SERVICE BULLETIN: 02001-2

Models:	TX-DS797 / TX-DS898
Symptom:	Static like Noise (tic, tic,) occurs when in surround mode with a limited possibility of Surround Back not functioning.
Cause:	Power Supply VCC for Q713 may be too high.
Solution:	Reduce VCC or Replace Q713. Must Perform Bulletin 02002-2 For <u>Dolby Digital Audio Drop Out</u> as well.

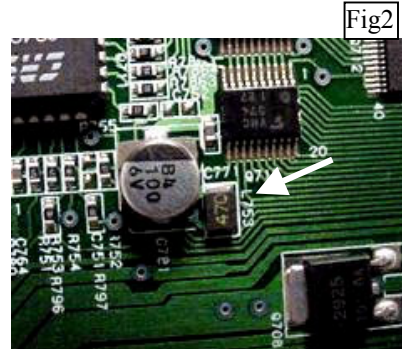
In some units Q713 IC, brand **ISSI**, IS62LV1024LL-70H was used [Fig1], where as in some NEC MPD441000LGU-B70X may be found. For those units using the **ISSI** SRAM and having the above aforementioned problem, you will need to replace the IC Q713 with PN#22241793R3 having NEC MPD441000LGU-B70X or Mitsubishi M5MV108DKV-70H brand label. If above part is to be replaced L753 need not be replaced. See Note.

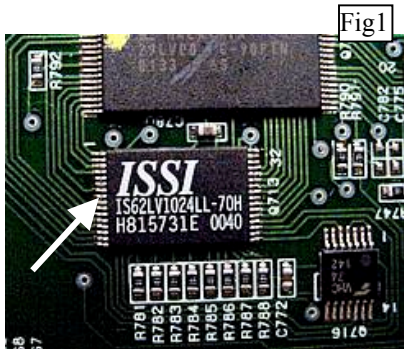
For units having not developed such problem and has the **ISSI** IC in place, it is highly recommended that L753 [Fig2] be changed to 33Ω (PN#433223304R1) chip resistors and need not replace IC.
